**TOWN OF ADDISON  
BUILDING REPORT**

**Facility Information:** **Facility Name:** Police Substation - Vitruvian  
**Facility Contact:** Lisa Pyles **Contact Phone:** 972-450-2878

**Accessology Inspector Information:**  
**Inspector:** Karen Jackson **Date:** April 19, 2017  
**Email:** Kjackson@accessology.com

## Summary Sheet for Police Substation - Vitruvian

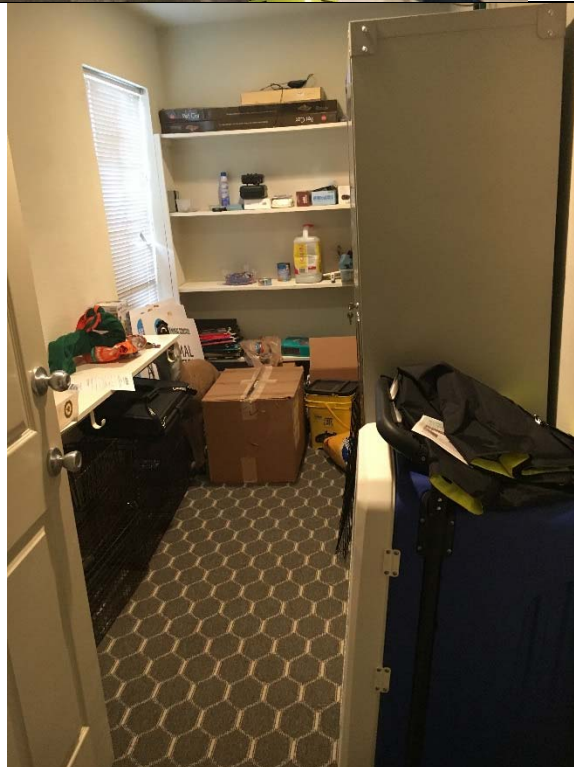
**Violation 6** - There is only a 16-3/8" maneuvering clearance on the pull side of the entrance door, a minimum of 18" maneuvering clearance is required.

Modify door to provide 18" minimum clearance on the pull side of the door.

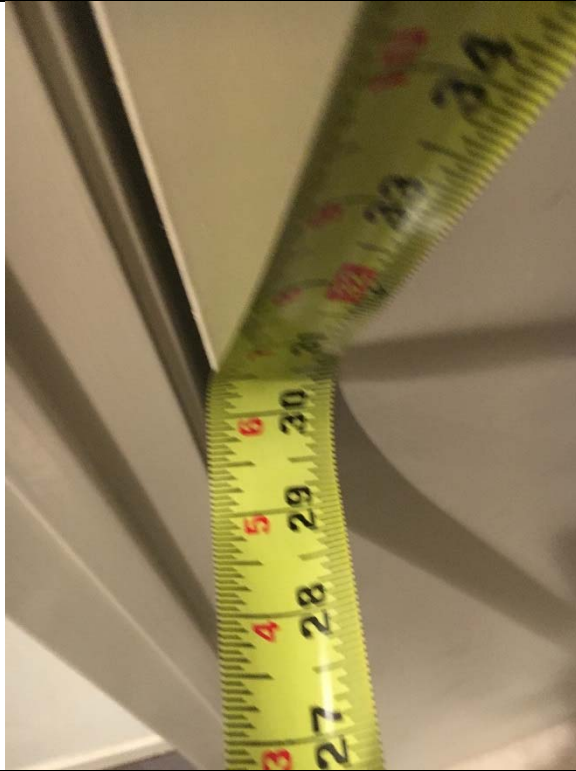
**Violation 8** - There is only a 11" maneuvering clearance on the pull side of the storage room door.

Modify door to provide 18" minimum clearance on the pull side of the door.

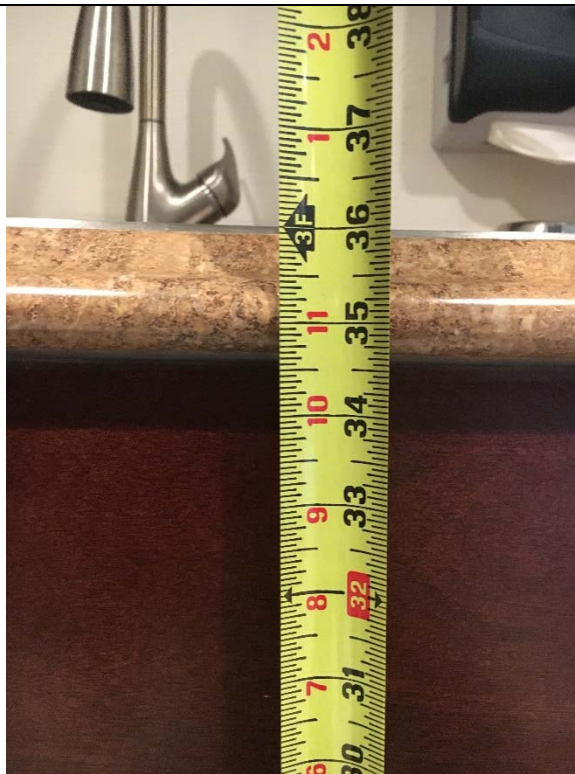
**Violation 10** - The centerline of the water closet is only at 15".

Relocate water closet to provide 16"-18" centerline.
